Docket Number:	15-AFC-01
Project Title:	Puente Power Project
TN #:	220216
Document Title:	Lawrence Hunt Supplemental Testimony
Description:	supplemental testimony
Filer:	Alicia Roessler
Organization:	Environmental Defense Center
Submitter Role:	Intervenor
Submission Date:	7/14/2017 4:30:39 PM
Docketed Date:	7/14/2017

Supplemental Testimony of Lawrence E. Hunt

RE Supplemental Biological Resources Evidence

Puente Power Project, Oxnard, California

Figure 1. Interior edge of dune ESHA (white line) and 100-foot buffer established around ESHA (yellow line) in relation to the proposed Project area (blue line) on MGS site.

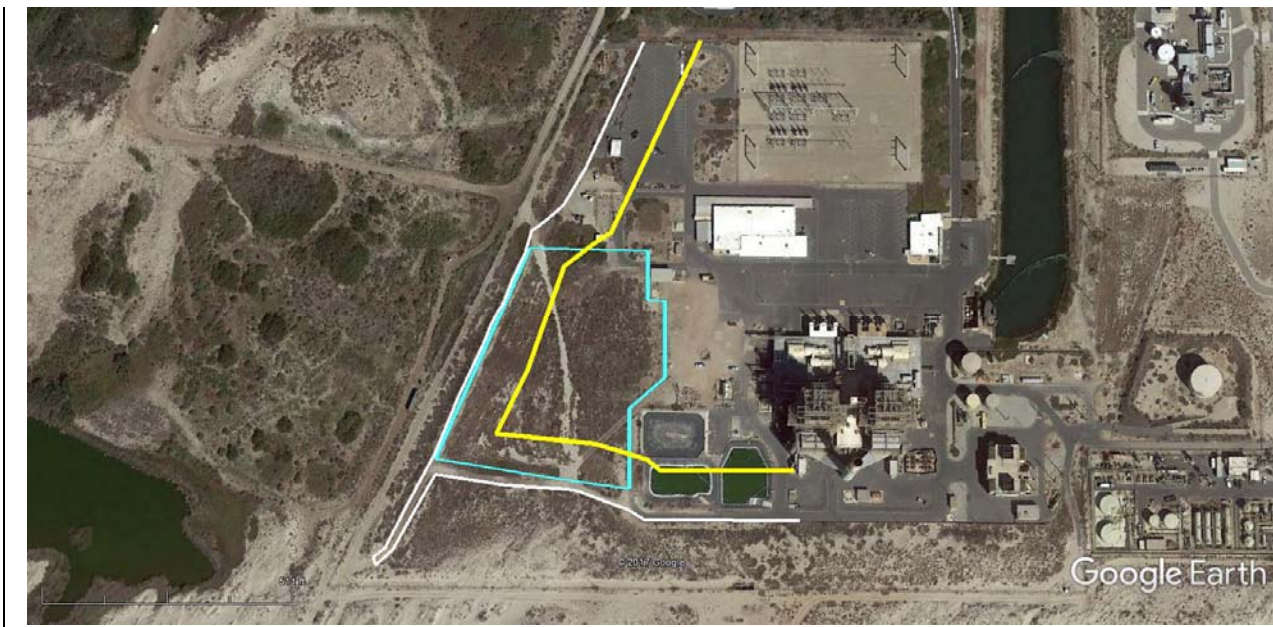
Dunes in and immediately around the Project area qualify as ESHA because they support documented occurrences of special-status plants and/or animals (e.g., globose dune beetle and California legless lizard). The City of Oxnard mapped dunes north, west, and south of the MGS site as "sensitive habitat" (City of Oxnard, 1982; Map No. 7, p. 27) and Local Coastal Policy 6d proscribed a 100-foot buffer around all resource protection areas (City of Oxnard, 1982, p. III-11)). If a 100-foot buffer were established around dune habitat identified in the buffer areas by Dr. Engel, the size of the proposed Project area would be significantly reduced, as shown in Figure 1 below.

As discussed above, and shown in Figure 1, the Survey Report reveals new information in the results that document the presence of the special-status globose dune beetle in the Project's northern and western buffer area.

As discussed above, and shown in Figure 1, photographs attached to the Declaration of Brian Trautwein (EDC, 2017), and the CNDBB (CNDBB, 2017), report the presence of special-status California legless lizard, a California Species of Special Concern, found in May 2017 in the buffer area ten feet from the Project site's Demolition Access Road.

Figure 1 (PSA Fig. 4-2.2, *Vegetation Communities*). Proposed location for P3 outlined in yellow. More than 75% of the site is dominated by wetland vegetation including woolly seablite, pickleweed, and slenderleaf iceplant whose wetland status is FACW, OBL, and FAC, respectively.

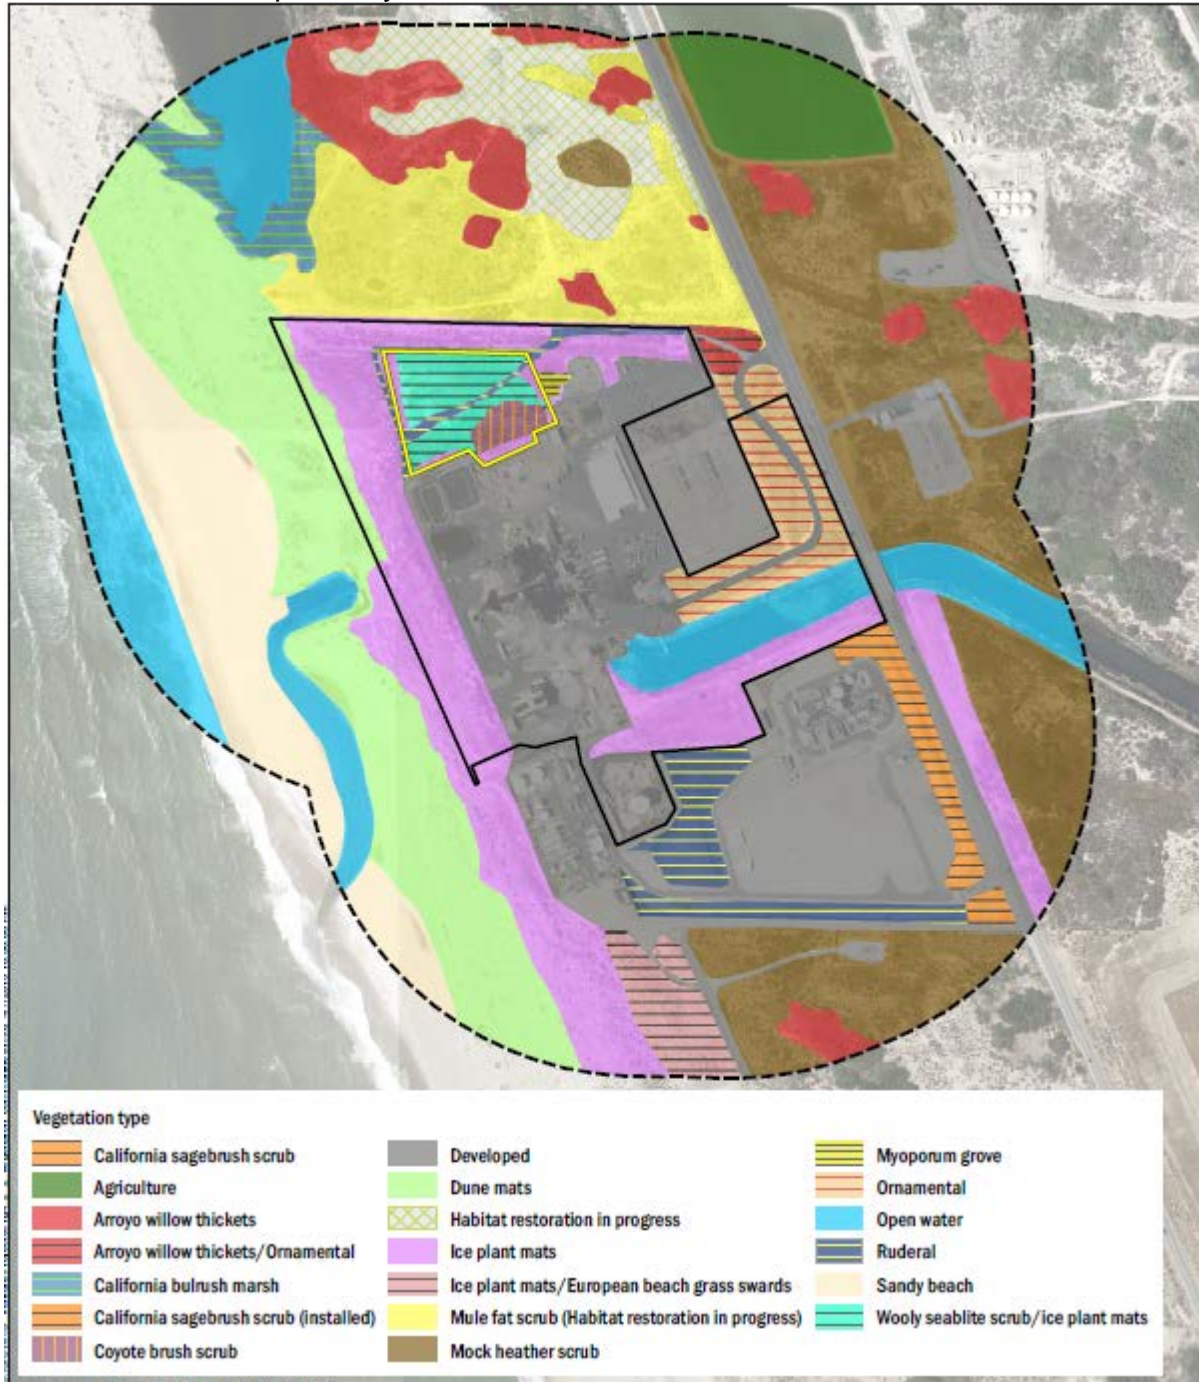
(*Mesembryanthemum nodiflorum*) (Figure 1). The National Wetland Inventory identifies the wetland status of these plants as FACW, OBL, and FAC, respectively. During the November site visit I carefully examined the vegetation in the area proposed for the power plant and confirmed that the area mapped as “woolly seablite scrub/ice plant mat” is dominated by the three species of wetland plants identified by AECOM.

Based on the Commission’s wetland definition, AECOM’s wetland delineation, and my site visit observations, I find that the area identified by AECOM as “woolly seablite/ice plant mat” within of the area proposed for Puente Power Plant is wetland habitat (approximately 75% of the site).
